Technical Note – Verification Report Condition 14

St Gabriels

Issue Draft – 10 September 2025

2998-MHT-CV-RP-0003

TITLE
PROPOSED BELOW GROUND DRAINAGE FOUL WATER LAYOUT

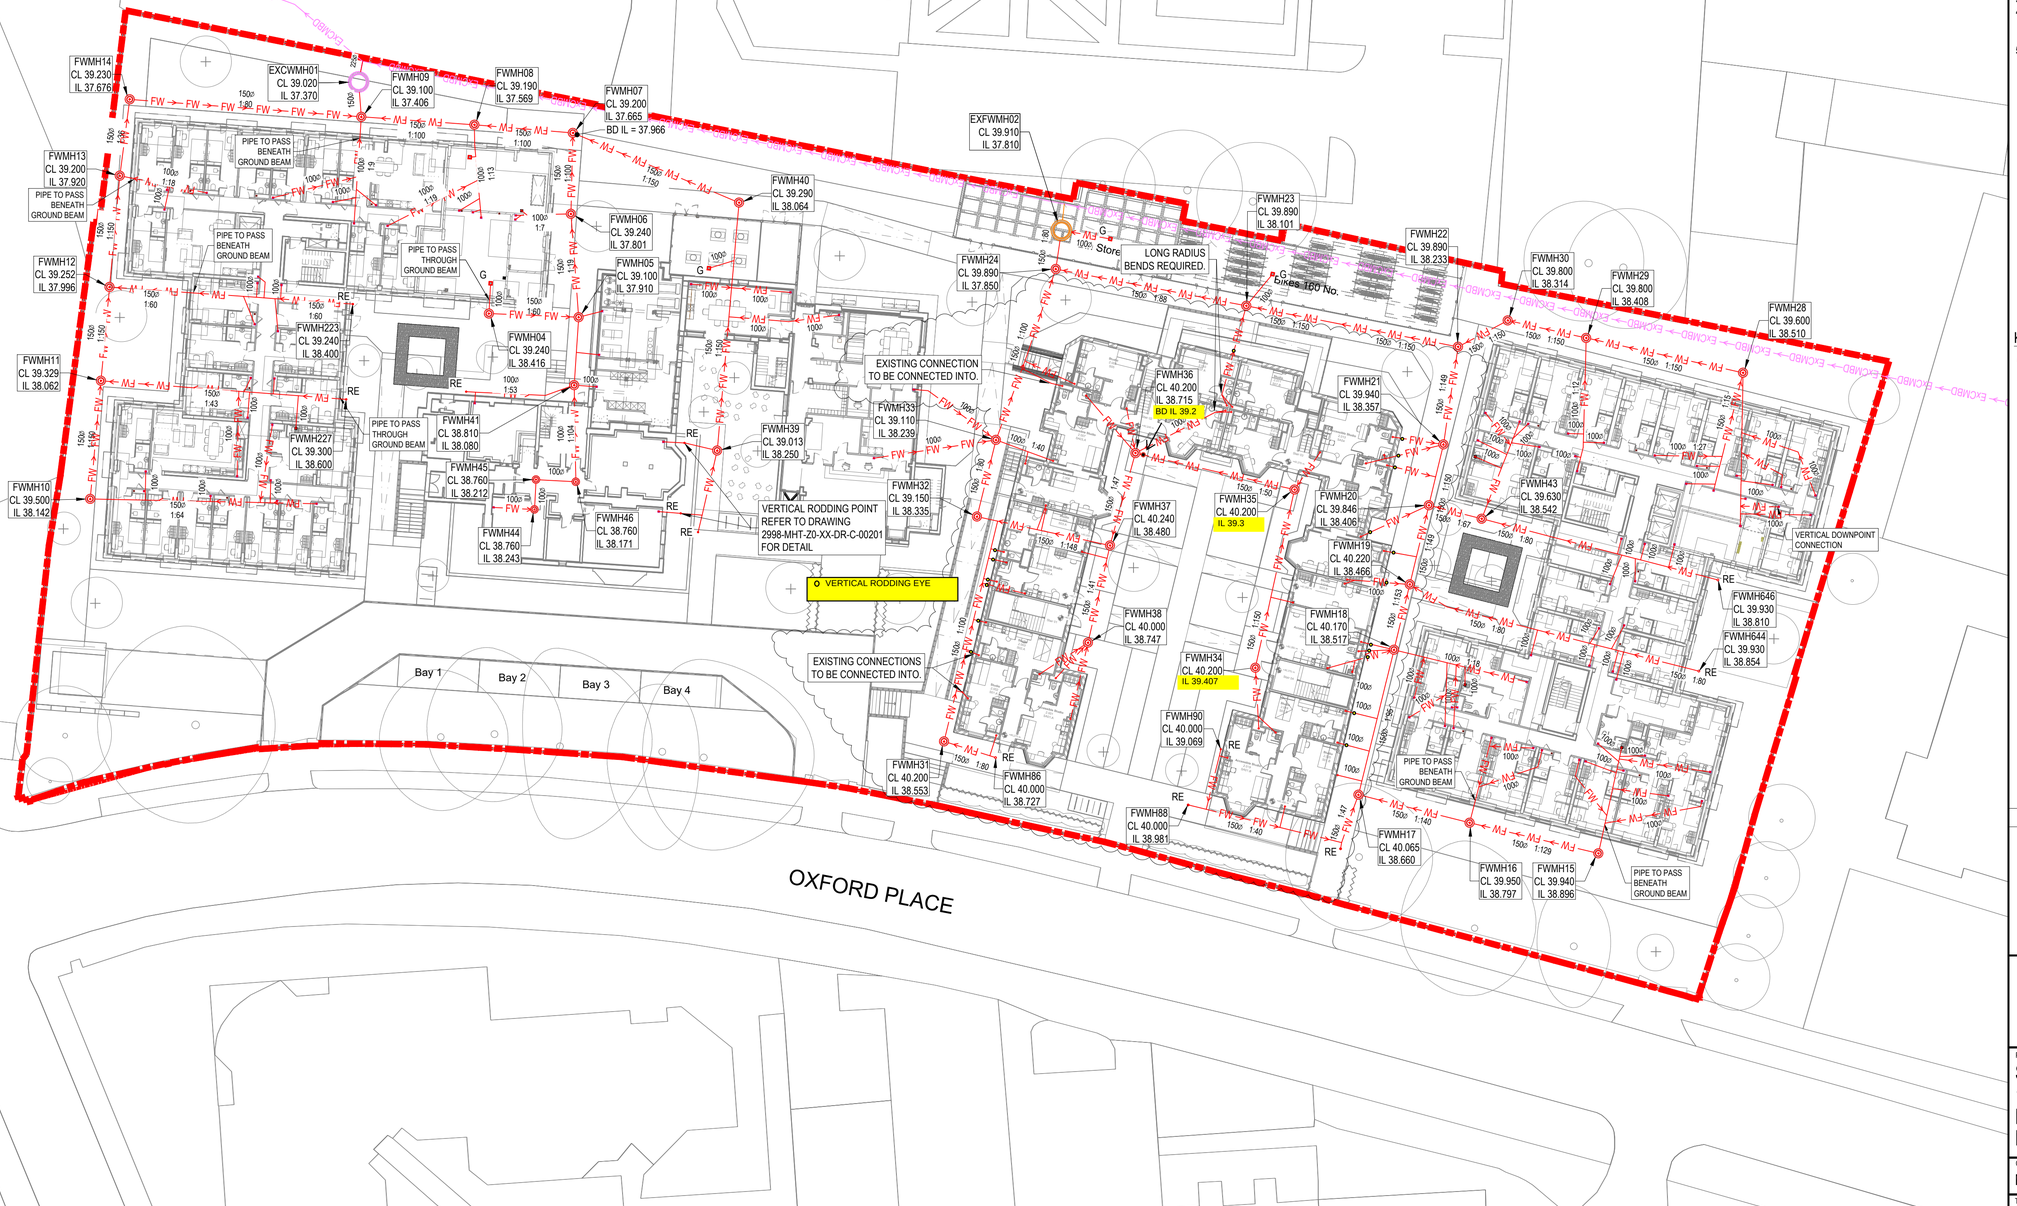
- Foul Water Drainage Layout – 2998-MHT-Z0-00-DR-C-00120 Rev C10 (with deviations marked)
- Tank Details – **Appendix C**
    - Attenuation Tank 1 Construction Details – Hydro WMS Rev A, updated June 2025

DRAWING TITLE: Proposed Attenuation Tank 1 Details

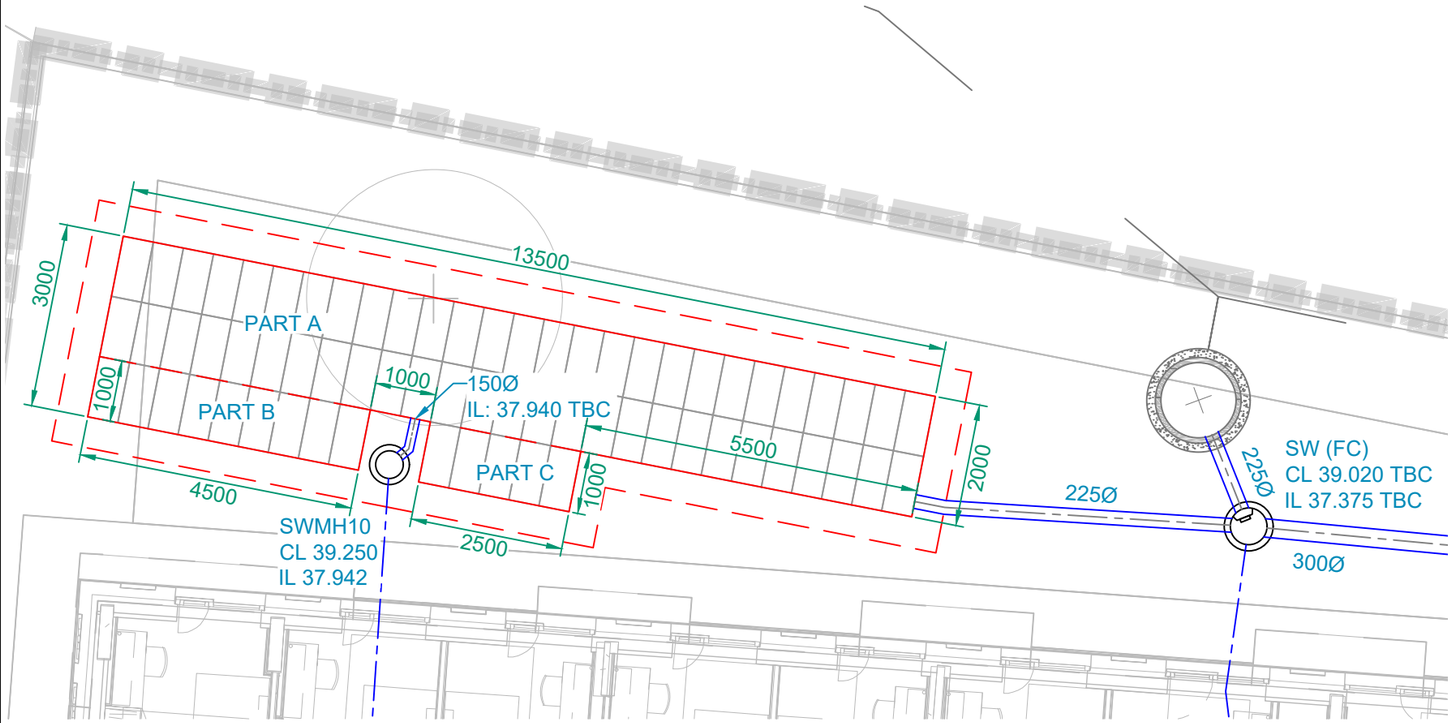
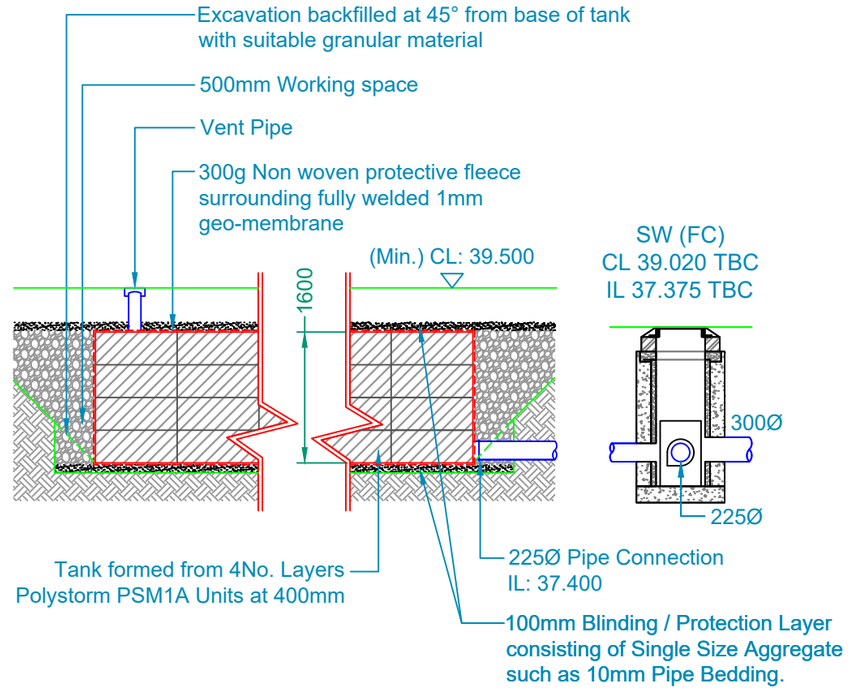
Updated Attenuation Tank 1 Dimensions	Tank 1 footprint and depth to provide approx. 48.5m³ net storage.	Adjusted tank dimensions (split configuration) providing 51.68m³ net storage to suit site constraints.	Improved storage provision; functionality and capacity exceed original design intent.
Alterations to Pipe Inverts and Cover Levels	Levels set based on original topographical survey and proposed finished ground levels.	Minor adjustments to inverts and cover levels reflecting as-built site conditions.	All gradients compliant; drainage network remains fully operational.

Part A:
13.5 x 2.0 x 1.6m deep
Part B:
4.5 x 1.0 x 1.6m deep
Part C:
2.5 x 1.0 x 1.6m deep

Total Vol = 54.40m³
Net Vol ≈ 51.68m³
At 95% min Void Ratio
272 PSM1A units
